INTERNATIONAL CODE COUNCIL 2012 - 2014 CODE DEVELOPMENT CYCLE Group B (2013)

PROPOSED CHANGES TO THE 2013 EDITIONS OF THE

April 21st – April 30th, 2013
Sheraton Dallas Hotel
Dallas, TX

**FIGURE C301.1
CLIMATE ZONES**

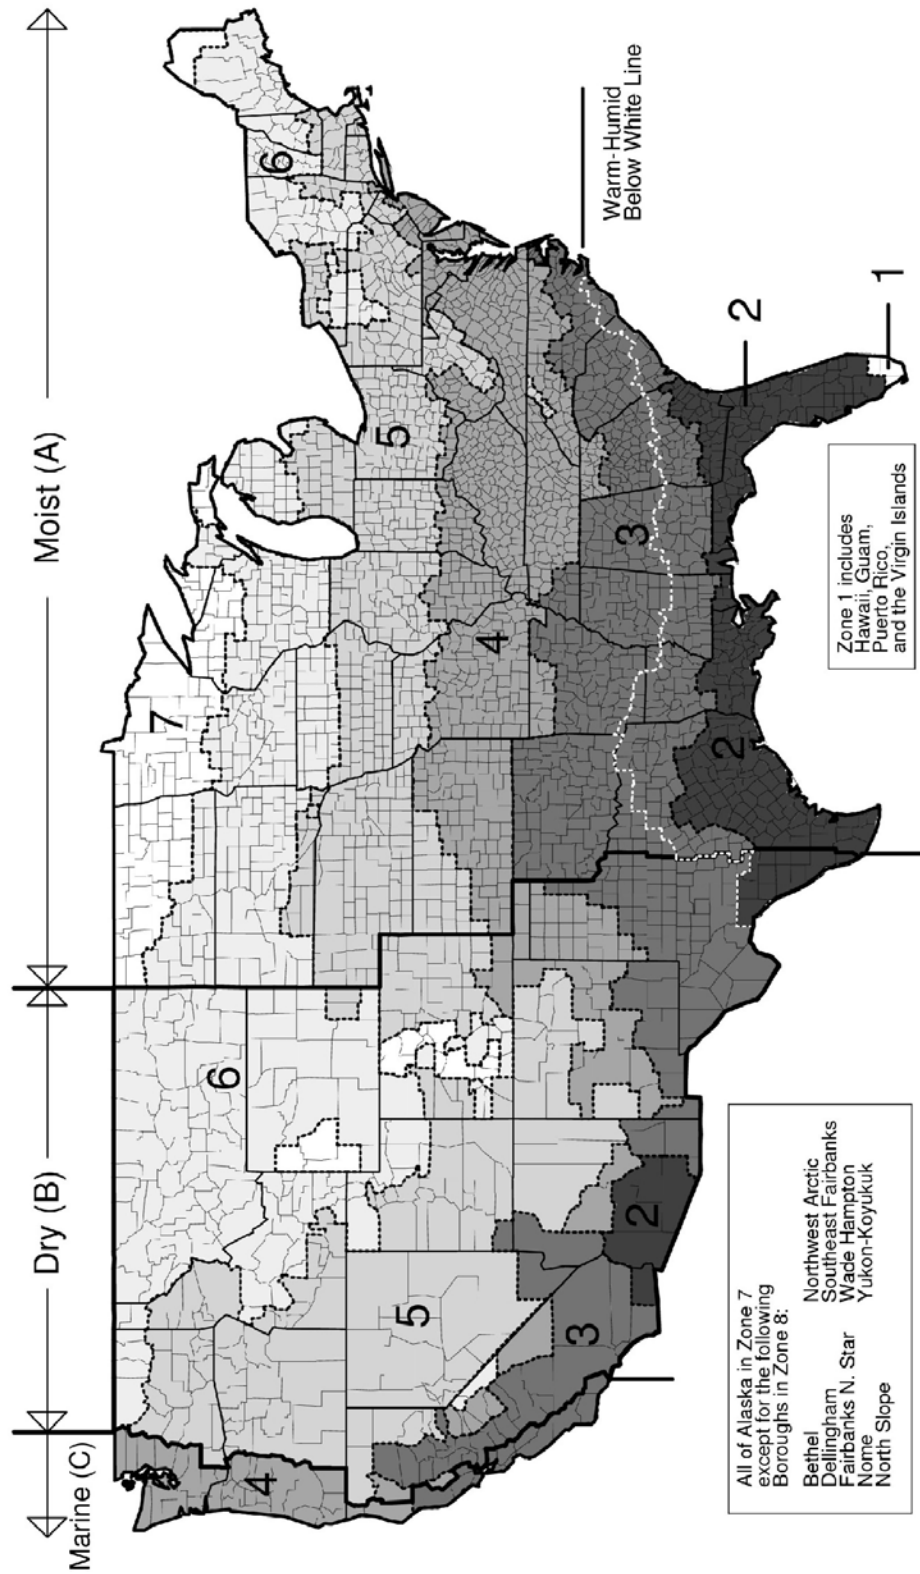
Revise as follows: End the Warm-Humid white line at the line separating the Dry (B) and Moist (A) moisture zones.

FIGURE R301.1 (N1101.10)
CLIMATE ZONES

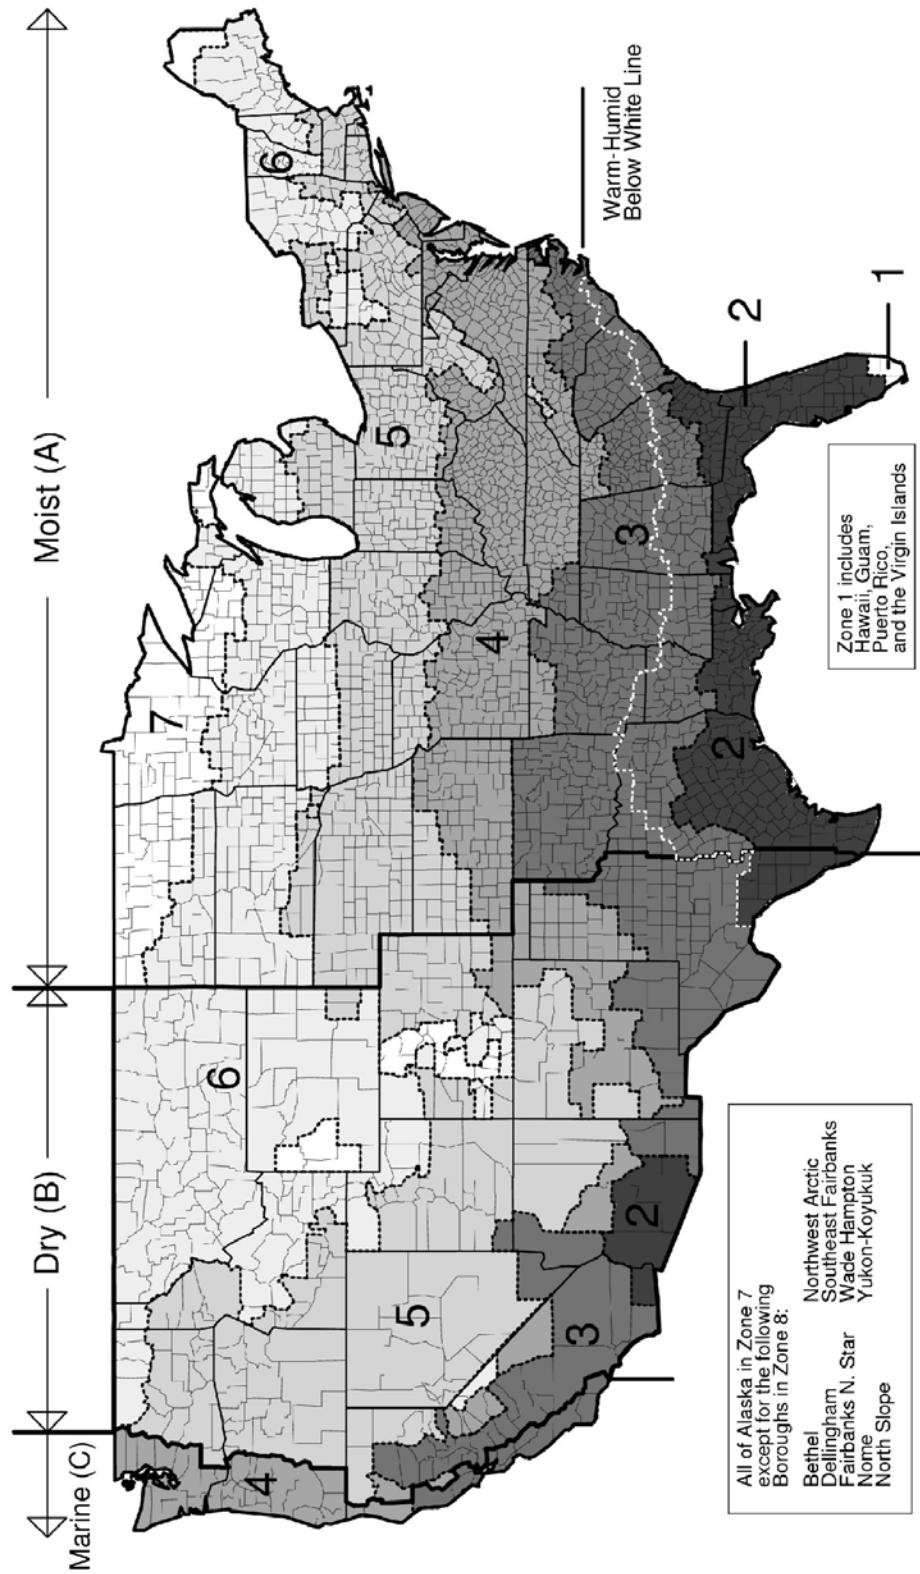
Revise as follows: End the Warm-Humid white line at the line separating the Dry (B) and Moist (A) moisture zones.

Figure 3203.4 3203.7.4 Mixed Commodities^{a,b}

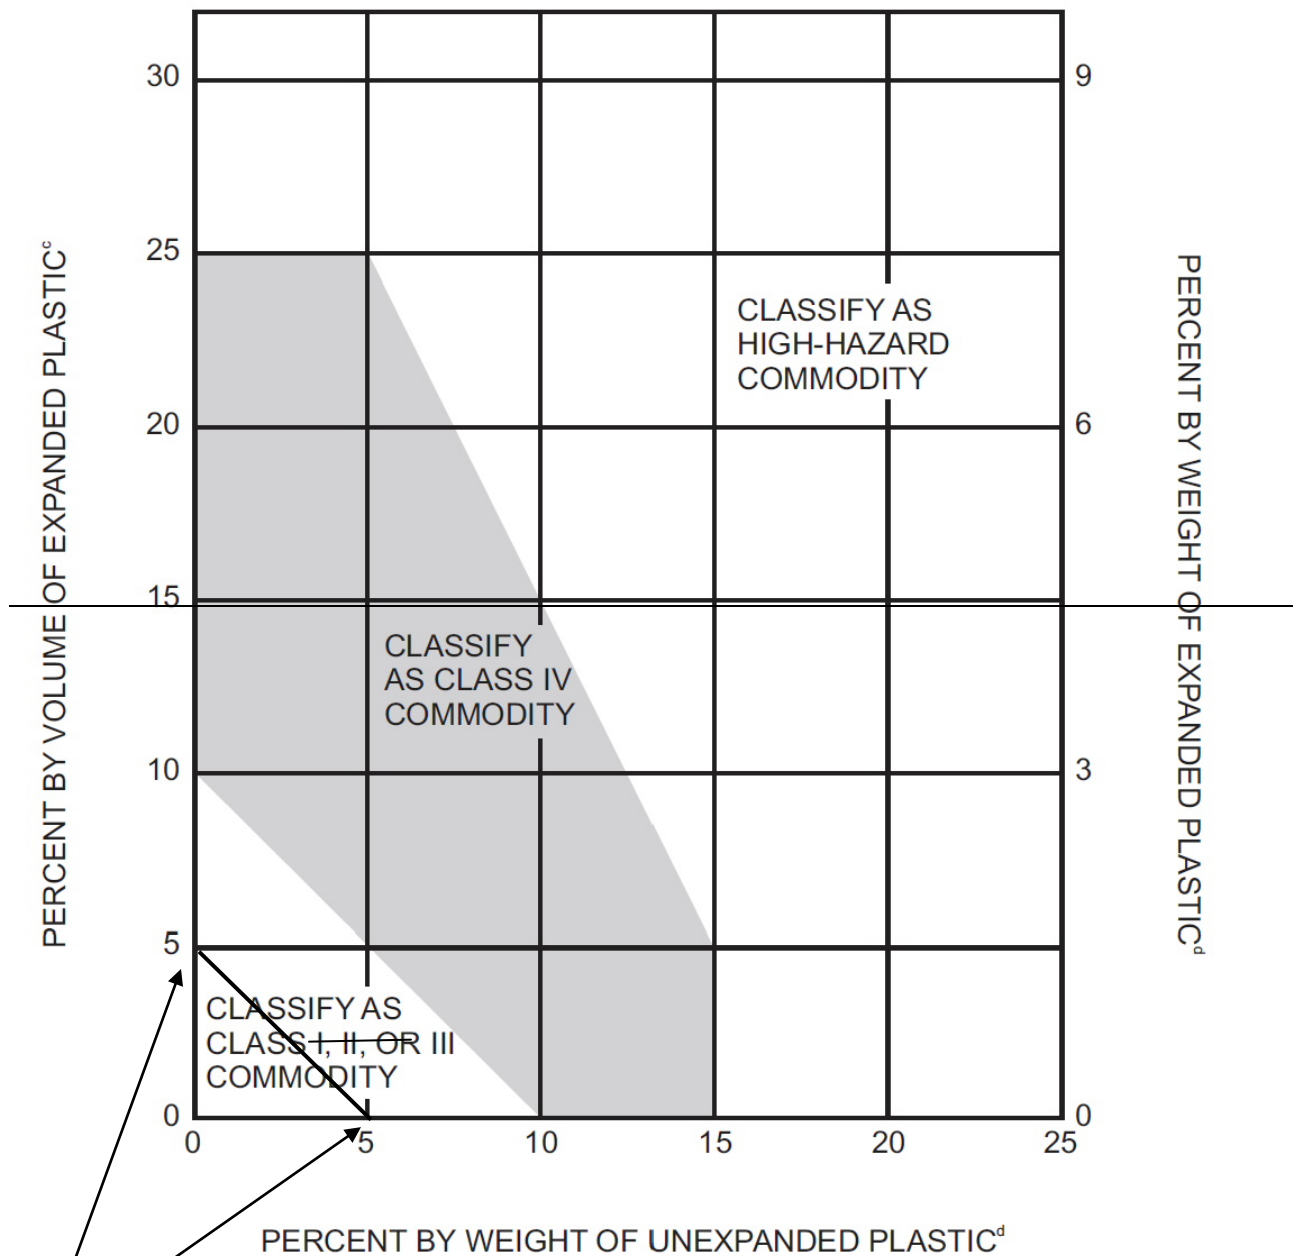
~~3203.4 3203.7.4 Limited quantities of Group A plastics in mixed commodities.~~ ~~Figure 3203.4 3203.7.4 shall be used to determine the quantity of Group A plastics allowed to be stored in a package or carton or on a pallet without increasing the commodity classification.~~
